34902A-08

Modification Recommended Service Note

34902A Reed Multiplexer Module for 34970A/72A, 16-Channel

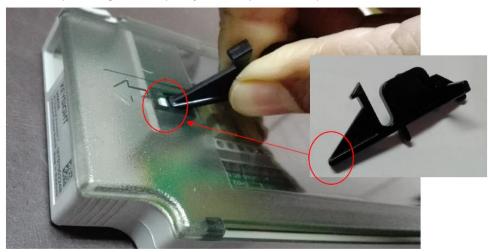
34902A module within the serial number may experience hard or too tight to insert into 34970A/34972A main frame. The top cover width and thickness dimension were out of specifications.

The module that has difficulty to insert into 34970A/34972A can be enhanced by replacing a new top cover. Users can contact Keysight Service Center to request for the enhance top cover and replace by referring to the following procedure as below:
